Subject: **Bid No. 8819-M7 – Sprinkler & Fire Alarm Modifications – Union Station / WRA**

ADDENDUM NO. 3

SPRINKLER AND FIRE ALARM
MODIFICATIONS PHASE 2
UNION STATION
WORCESTER, MA

FAD104

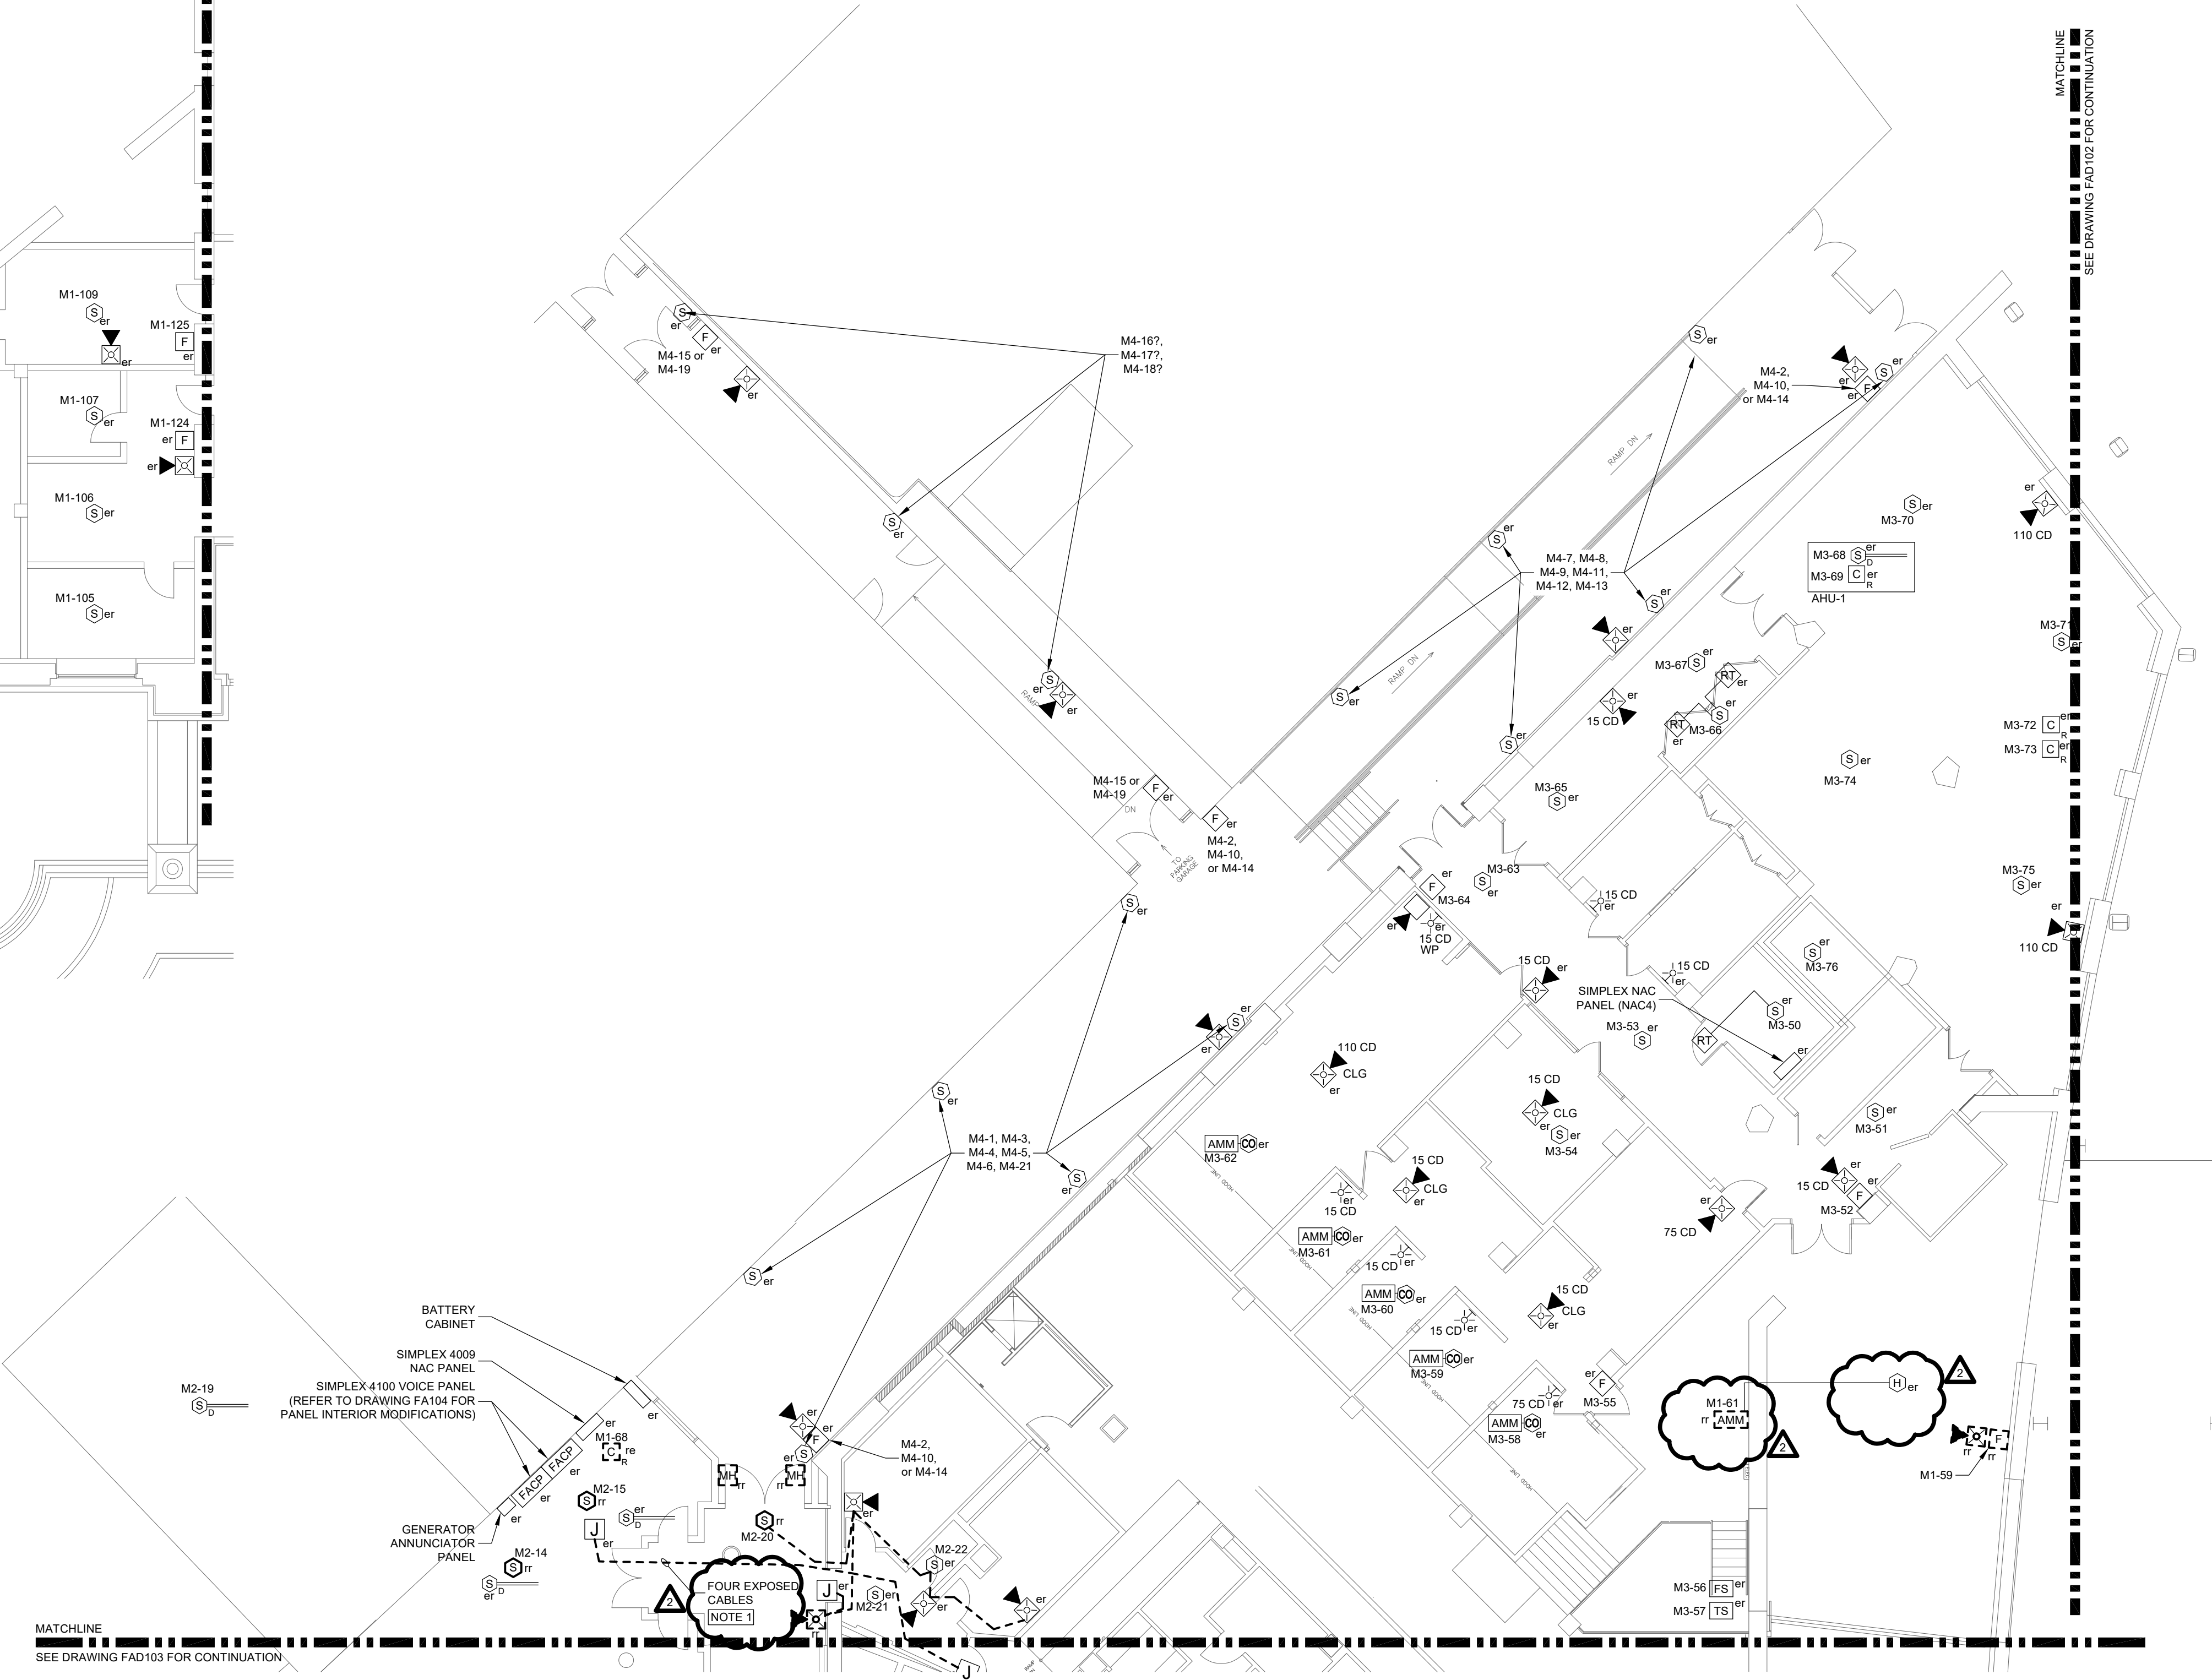
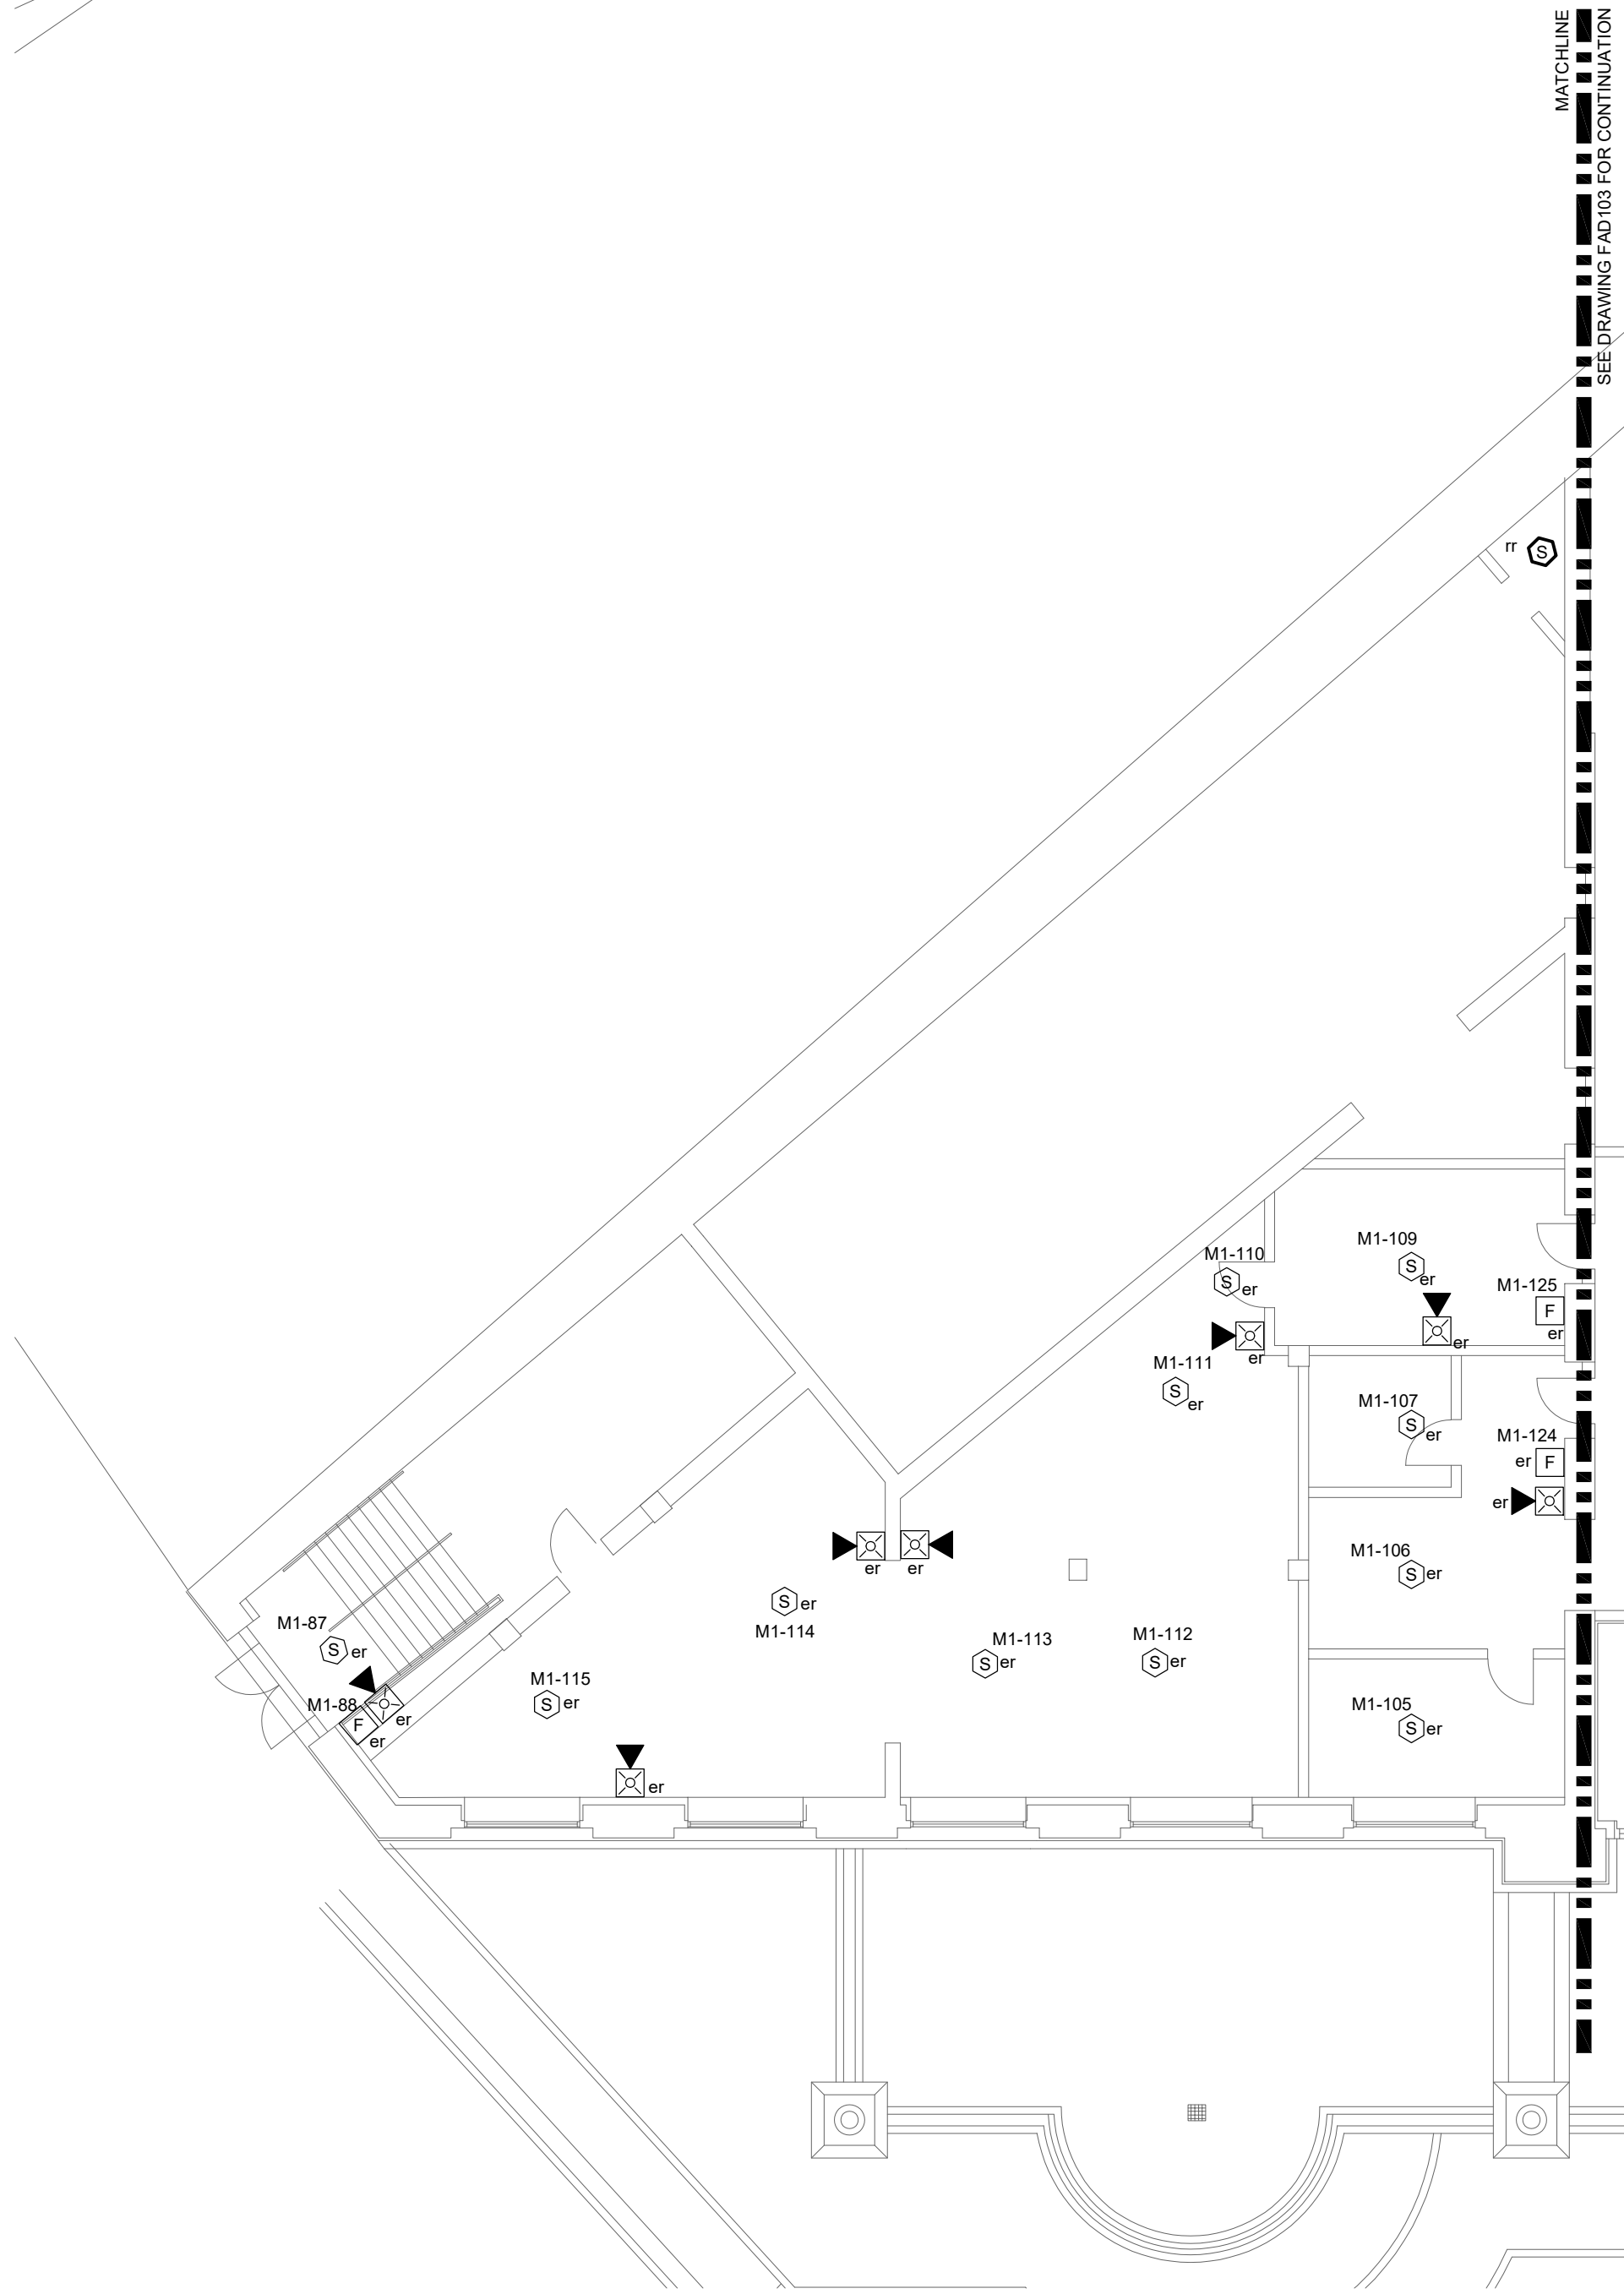
Drawing FAD104, Electrical Fire Alarm First Floor Demolition Plan, Revise as follows:

- DELETE reference to Note 1 at Addressable Monitor Module (M1-61).
- REVISE heat detector monitored from Addressable Monitor Module M1-61 from “Remove Existing” to “Existing to Remain”.
- REVISE Keyed Note 1.
